MEMORANDUM

REVIEW TYPE: Preliminary Plan of Subdivision

PROJECT NAME: Quince Orchard Estates

CASE #: 120070250

(Attachment B – proposed plan)

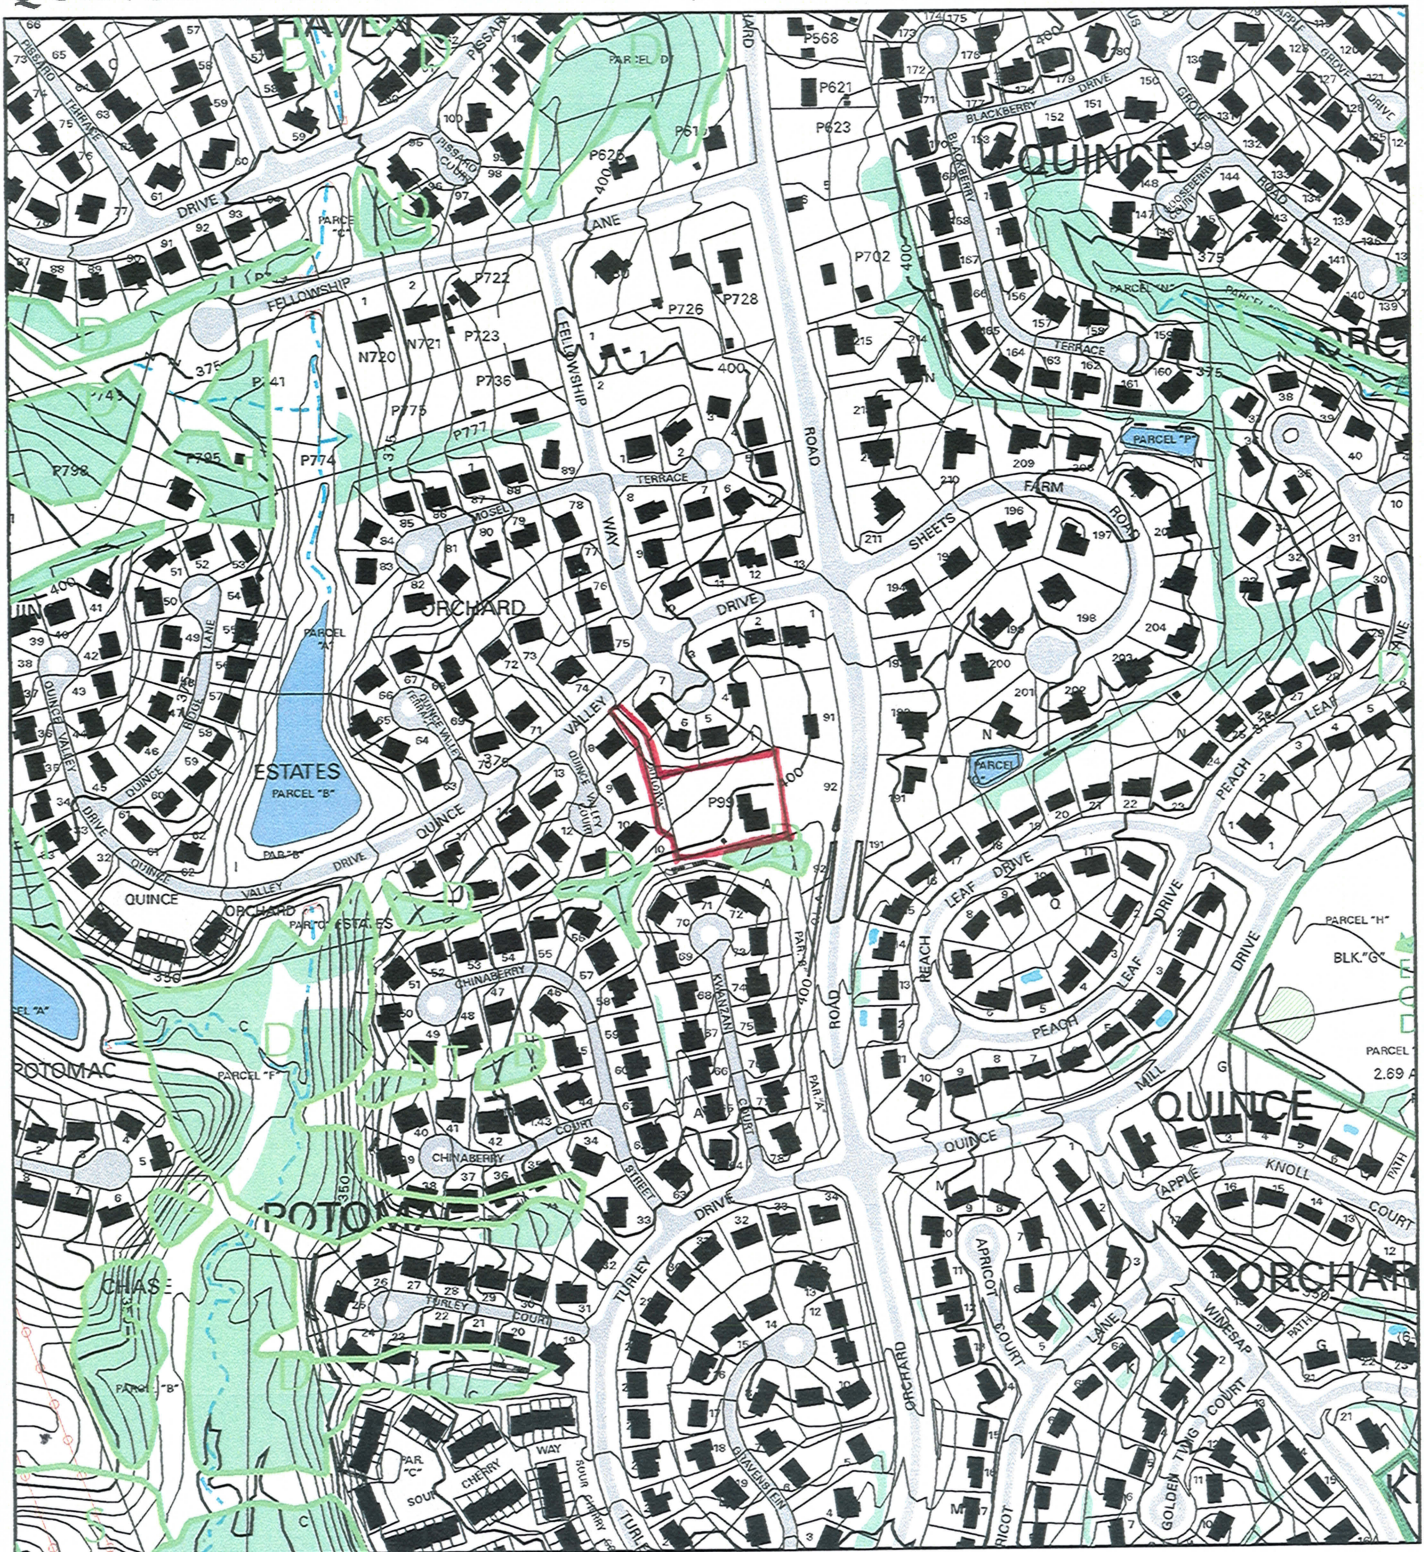
Although the subject property includes recorded land, the plan is not considered a resubdivision because the recorded land is an unbuildable outlot. The applicant proposes to create 2 lots to accommodate 2 one-family detached residential dwelling units. Proposed Lot 93 contains 27,947 square feet and Proposed Lot 94 contains 22,050 square feet. The existing house on Proposed Lot 94 is to be removed. Access to the 2 lots is proposed from Quince Valley Drive via a 20-foot wide private driveway. A reciprocal ingress/egress and utilities easement is proposed along the driveway to the point where it is no longer shared. Neither Lot 93 nor Lot 94 have adequate frontage on a public road and, therefore, the applicant requests a waiver of Section 50-29 (a)(2) of the Subdivision Regulations. This waiver request is discussed in greater detail in the Compliance section on page 4 of this report. The lots are to be served by public water and sewer.

This application has been reviewed for compliance with the Montgomery County Code, Chapter 50, the Subdivision Regulations. Access and public facilities will be adequate to support the proposed lots and uses. The proposed lots have pipestem configurations. Orientation of the lots is to the rear of existing lots that front on Fellowship Way. Currently, there are pipestem configurations in the immediate area with a similar orientation. The size and width of the proposed lots are in accordance with standards of the R-200 zone and are consistent with surrounding properties. As such, it is Staff's opinion that the proposed lot size, width, shape and orientation are appropriate for the location of the subdivision.

Neither Lot 93 nor Lot 94 has adequate frontage on a public road. As a result, the applicant requests a waiver of Section 50-29(a)(2) of the Subdivision Regulations, which states:

The applicant’s justification for creating 2 lots without frontage cites the land-locked nature of the property and subsequent limited access points that make it difficult to provide adequate street frontage. Based on the approval from the Department of Fire and Rescue dated July 3, 2007, the proposed 20-foot wide private driveway will be adequate for emergency vehicles and other public services. Placement of an ingress/egress and utilities easement on the driveway will allow for the installation of public utilities. Creating lots without frontage in this particular location will not inhibit further subdivision since surrounding properties are already developed. In addition, the proposed development does not exceed the creation of two (2) lots without frontage. For these reasons, staff finds the preliminary plan complies with Section 50-29 (a)(2) of the Subdivision Regulations and supports the waiver request.

RECOMMENDATION: Approval, including a waiver of lot frontage under Section 50-29(a)(2) of the Subdivision Regulations, and subject to the following conditions:

- 1) Approval under this preliminary plan is limited to 2 lots for 2 one-family residential dwelling units.
- 2) The applicant must comply with the conditions of the forest conservation exemption and the approved tree save plan signed November 9, 2007.

- 3) The record plat must reflect common ingress/egress and utility easements over all shared driveways.
- 4) The applicant must comply with the conditions of the Montgomery County Department of Permitting Services (MCDPS) stormwater management approval dated February 21, 2007.
